Illinois Department of Transportation

Memorandum

Subject: Drainage Details for Structures

Date: September 30, 2005

TYPICAL SECTION THRU
INTEGRAL ABUTMENT

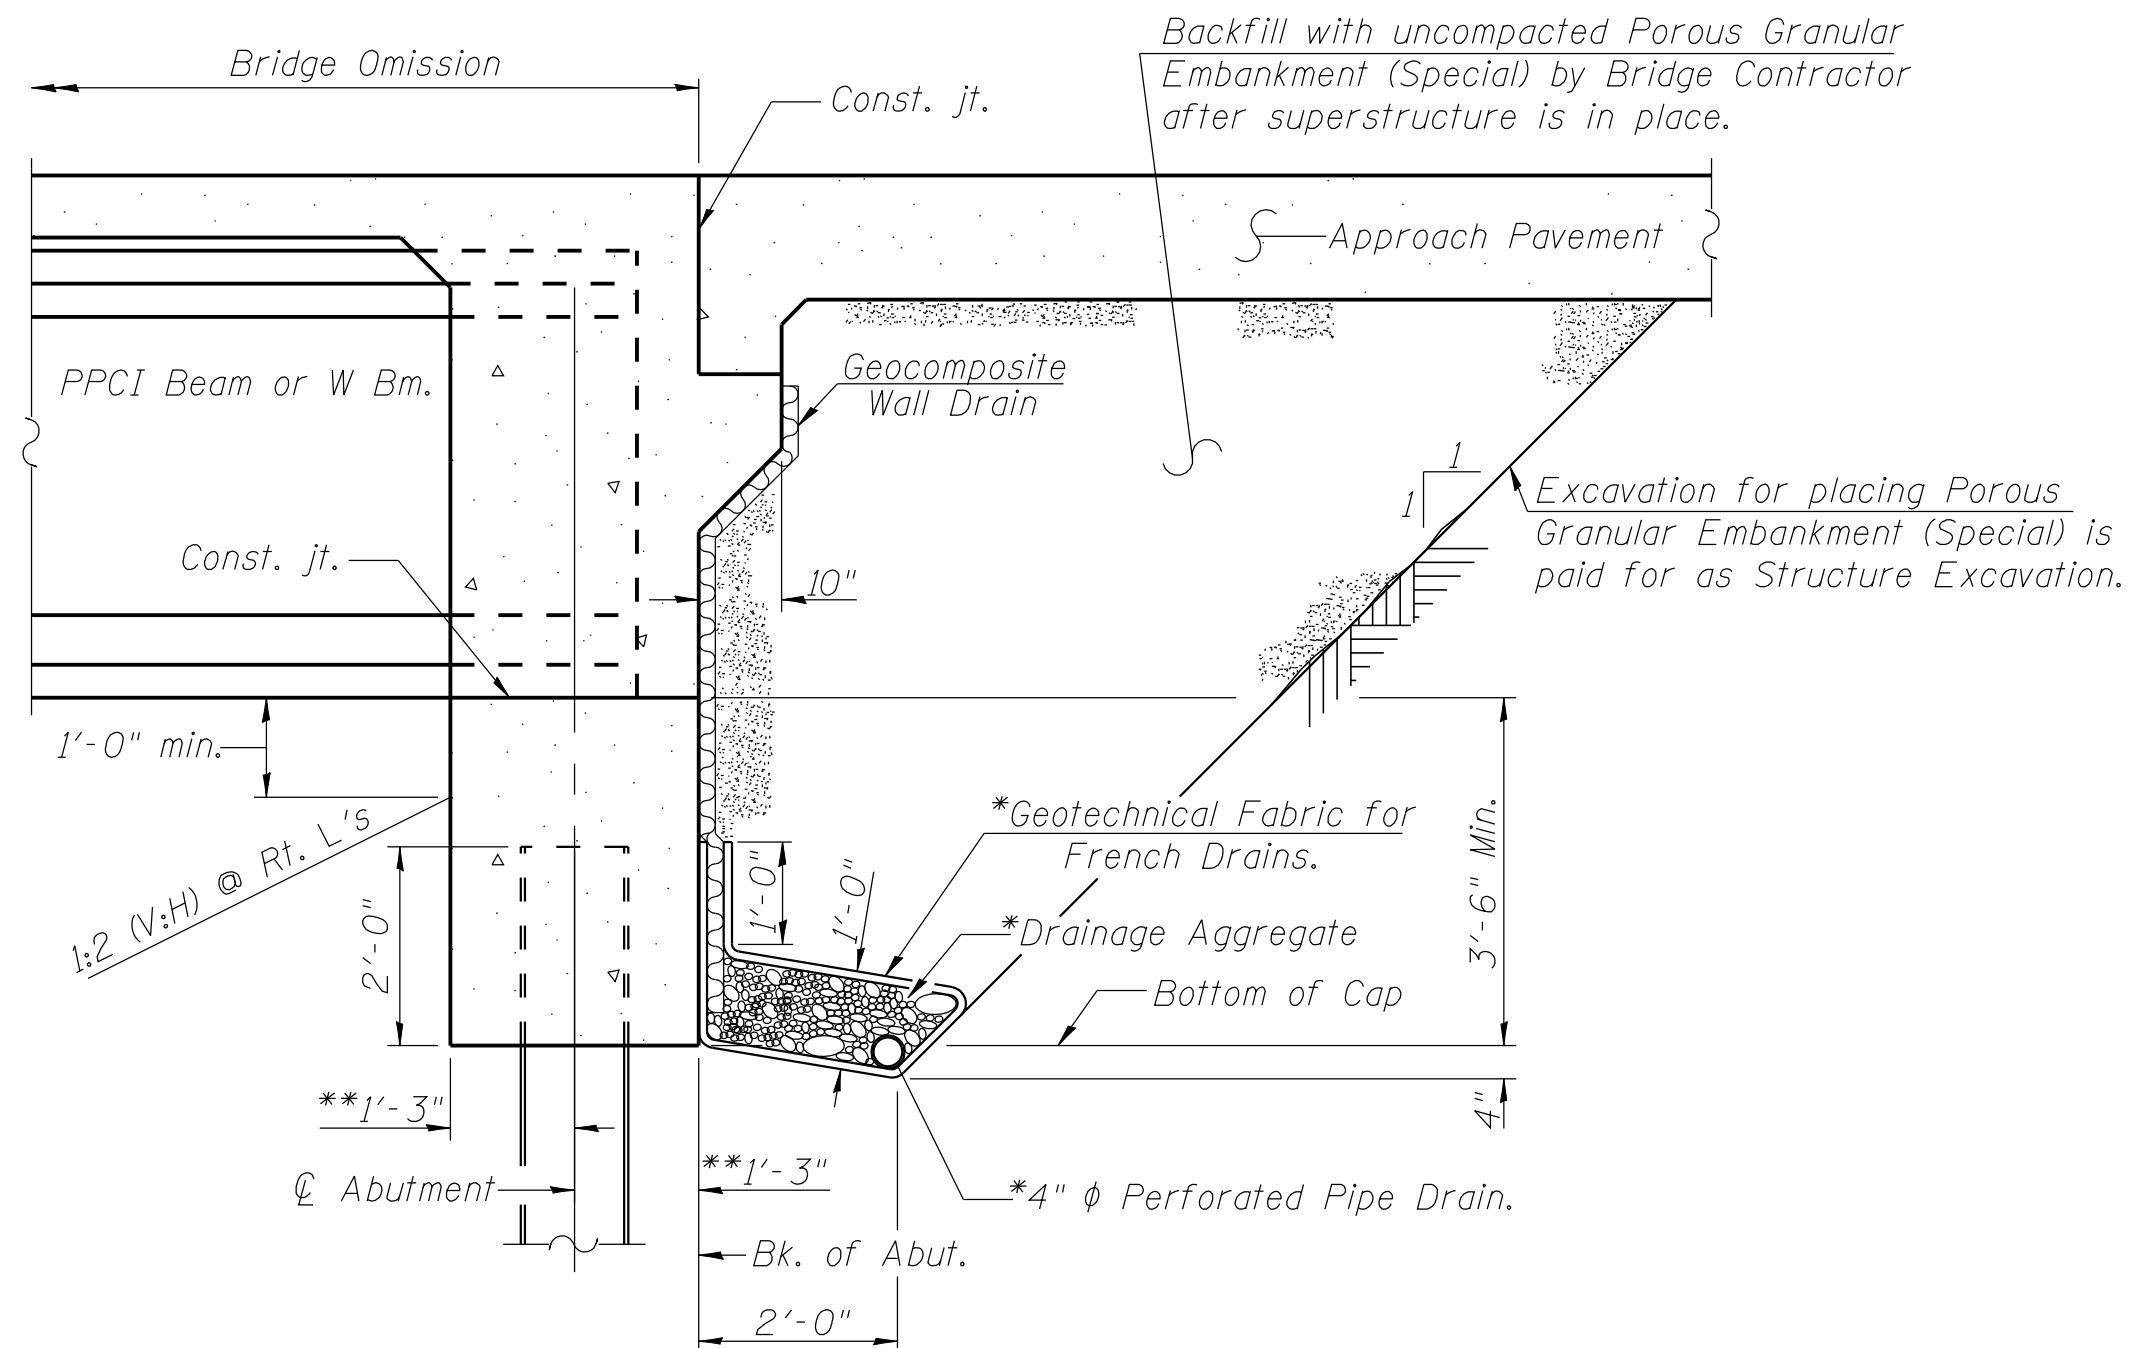
Integral, Semi Integral and Pile Bent Abutments. The Geotechnical Fabric for French Drains will no longer be required along the 1:1 slope between the existing soil and backfill. Its use will be limited to encasing the drainage aggregate around the perforated pipe underdrain. A geocomposite wall drain has been added to the detail to ensure efficient drainage to the pipe underdrain. The pipe underdrain, drainage aggregate, and geotechnical fabric will all be included in the pay item PIPE UNDERDRAINS FOR STRUCTURES covered by the new Guide Bridge Special Provision (GBSP) 51. The geocomposite wall drain will be measured and paid for according to the Standard Specifications. In addition the backfill material has been redefined as Porous Granular Embankment (Special) to better distinguish it from the embankment material specified in the roadway plans. Porous Granular Embankment (Special), as covered by GBSP 52, is a newly created item where the aggregate types and gradations have been expanded to reduce cost, provide Districts with more alternatives, and eliminate the need for geotechnical fabric against existing soil as previously noted.

TYPICAL SECTION THRU
FILLED VAULTED ABUTMENT

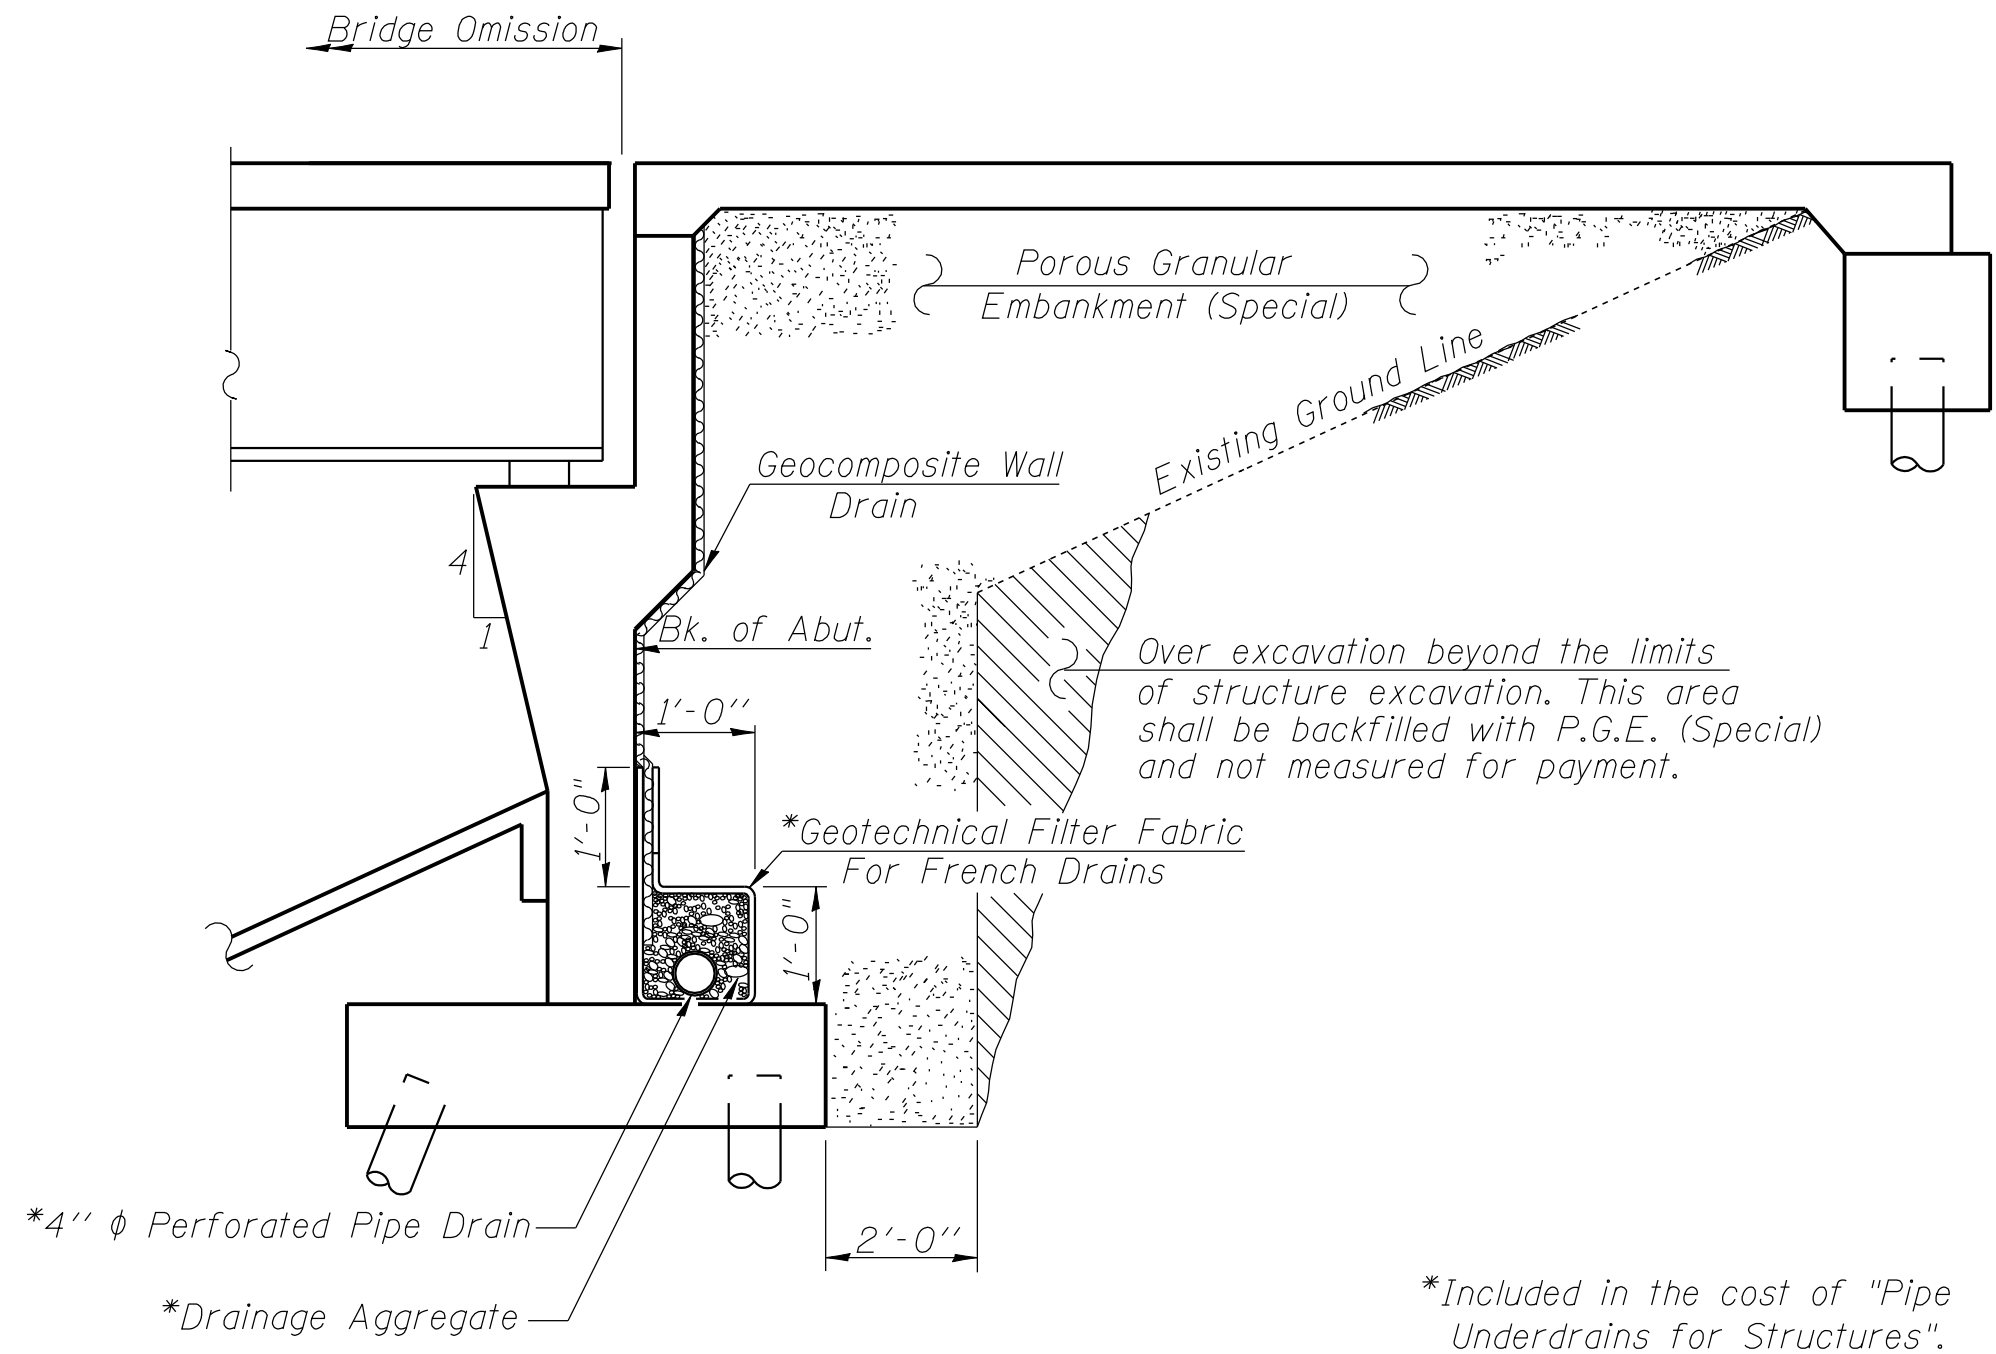
Vaulted Abutments. A detail for drainage treatment of filled vaulted abutments has been developed. The sand backfill has been replaced with PGE (Special) and the use of the geocomposite wall drain and pipe underdrain have been introduced.

**TYPICAL SECTION THRU
DRILLED SOLDIER PILE WALL
WITH C.I.P. FACING**

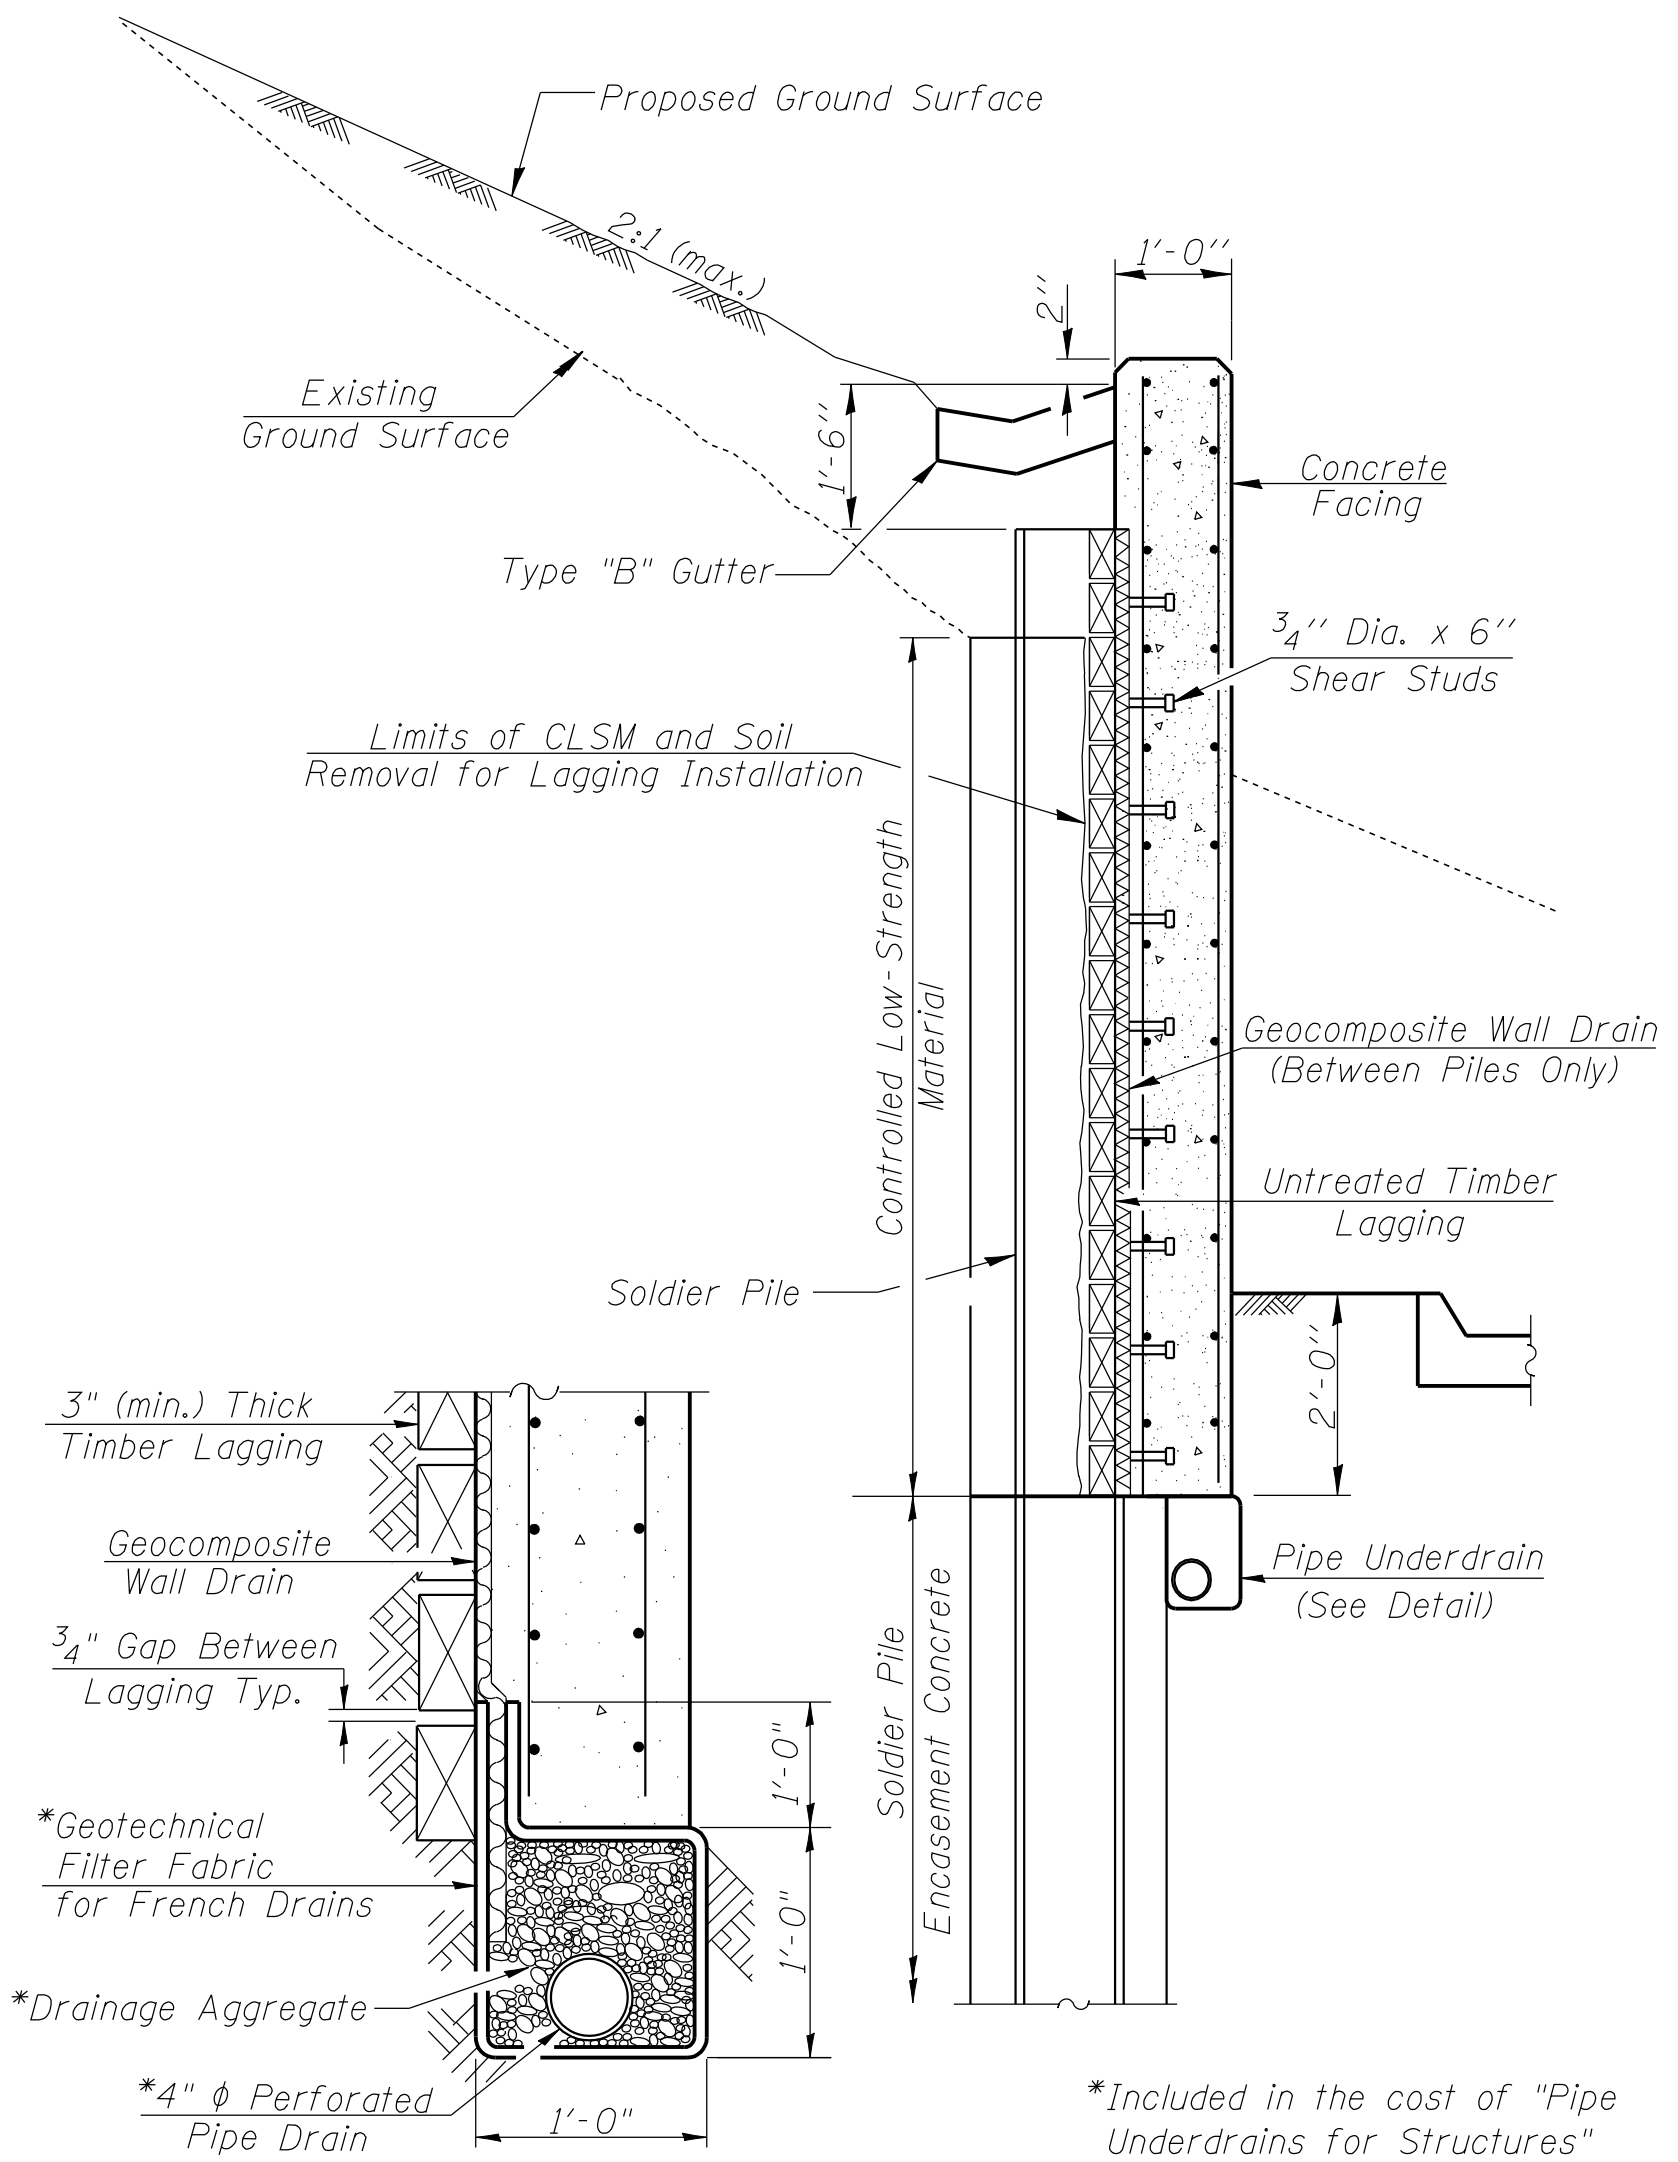
Soldier Pile Walls. Typical cross sections were developed depicting the components and drainage details required. Additional details and policies for soldier pile walls will follow in the future.
